December 1, 2022

Re: Proposed Large-Scale Ground-Mounted Solar Photovoltaic Installation, 0 Route 25, Wareham, MA  
Response to Charles L Rowley Consulting Engineer Comments

On behalf of our Client, Wareham PV I, LLC, VHB has prepared this letter in response to the comment letter provided by Charles L. Rowley on November 3, 2021, regarding the project mentioned above.

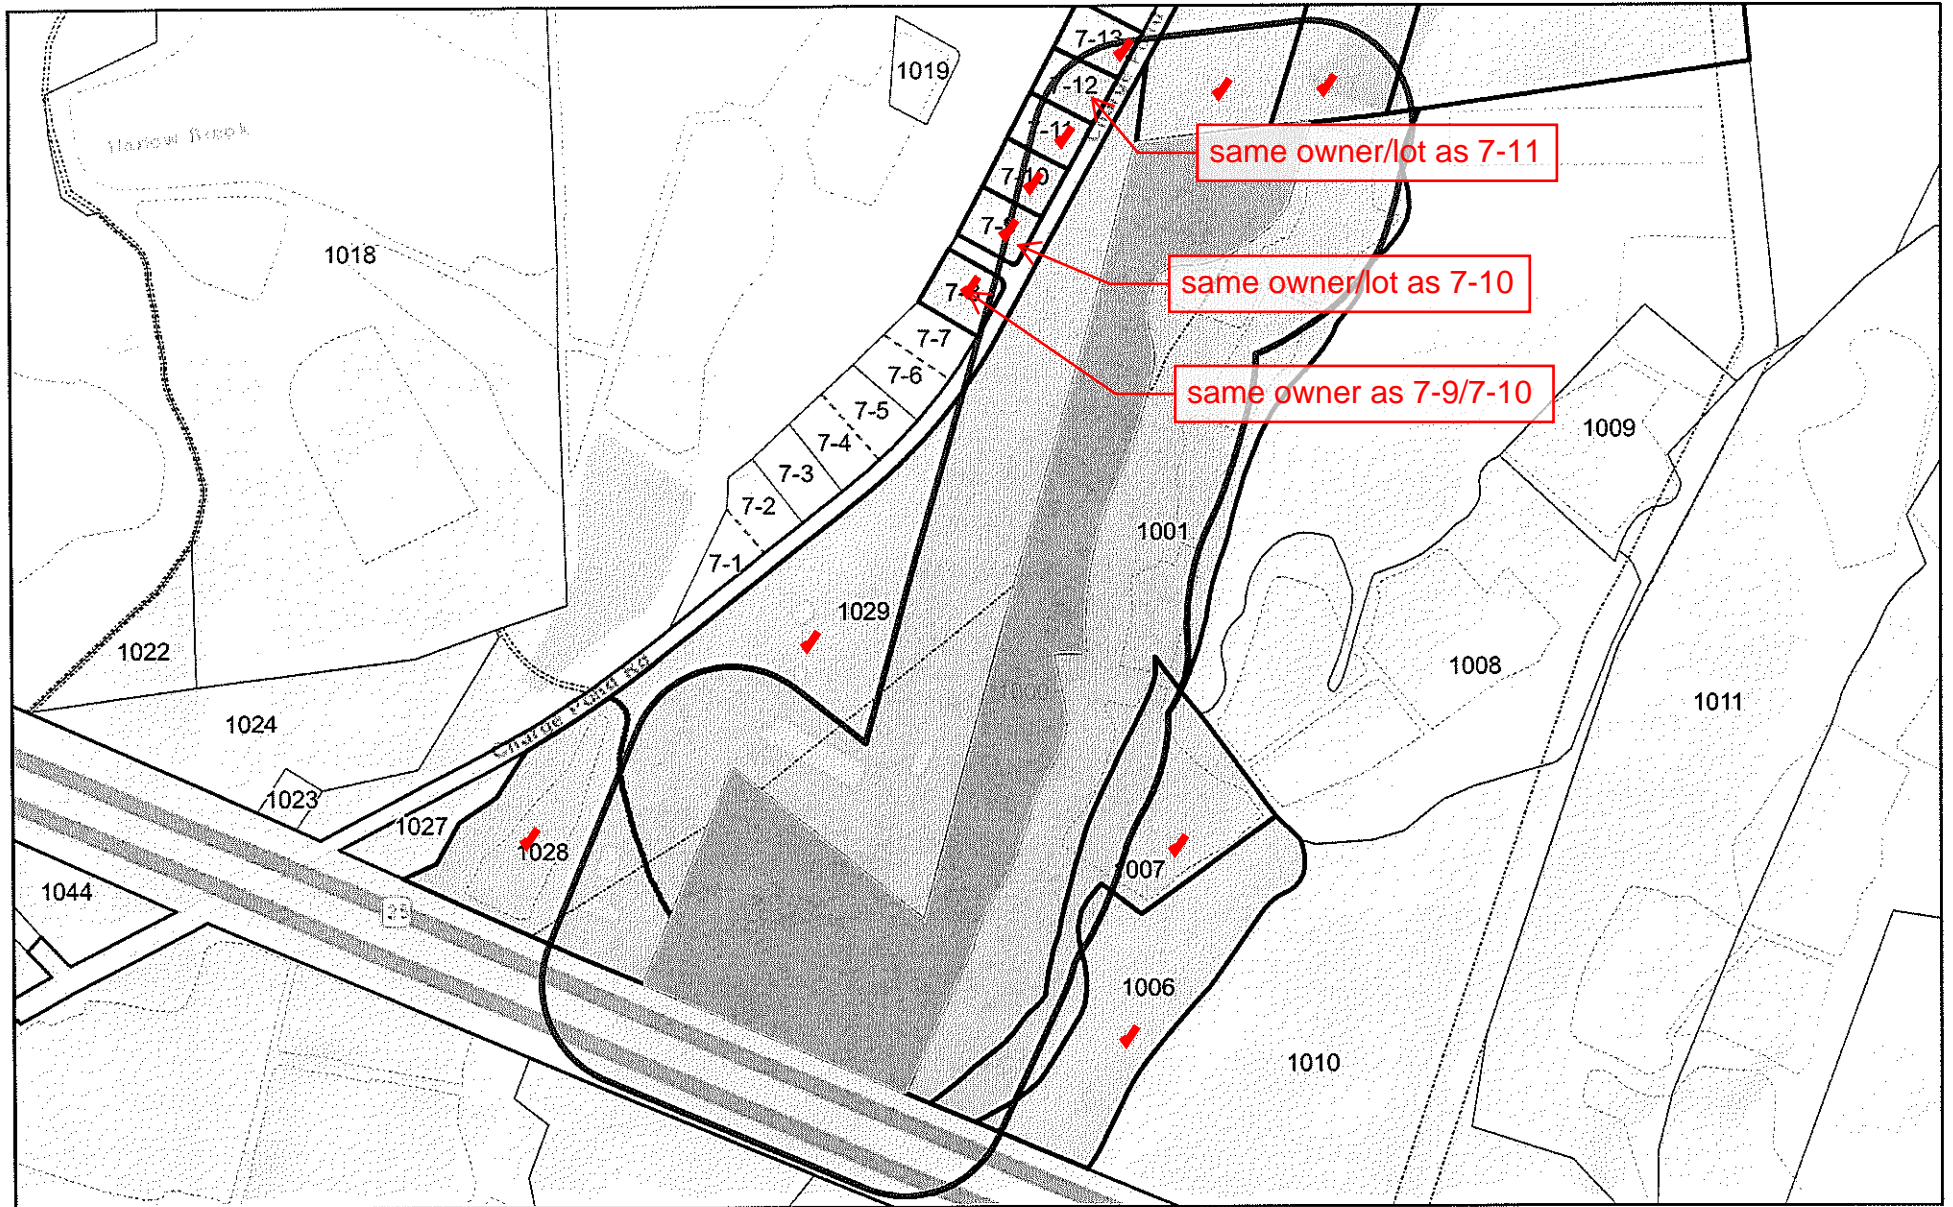
1. The Abutter Notice list appears to be incomplete and should be checked. There are six lots that may have been left out of the notice list for abutters and abutters to abutters within 300 feet of locus.

*The abutter notifications were sent based on the certified abutters list from the assessors office provided to VHB and the Client on June 24, 2021. The certified abutters list, as well a copy of the current assessors' tax map for the properties, is attached.*

*As you can see on the tax map, Parcels 113\_7-9 and 113\_7-10 are divided by a dotted line to indicate that they are separate tax parcels but are part of the same lot. This also applies to Parcels 113\_7-11 and 113\_7-12. This may have been the cause of confusion as the map provided with the certified abutters list appears to show these tax parcels lots as separate lots (divided by a solid line). However, the certified abutters list notes that the list presents "certified abutters as they appear on our tax rolls as of 5/15/2021." Sure-Cran Services LLC owns multiple lots within the radius of the parcel (115-1007, 115-1006, 113-1028, 113-1012) and appears in the certified list only once to avoid duplicates.*

*It is VHB's understanding that the assessors office provided a complete abutters list and the appropriate owners were notified as part of the original filing.*
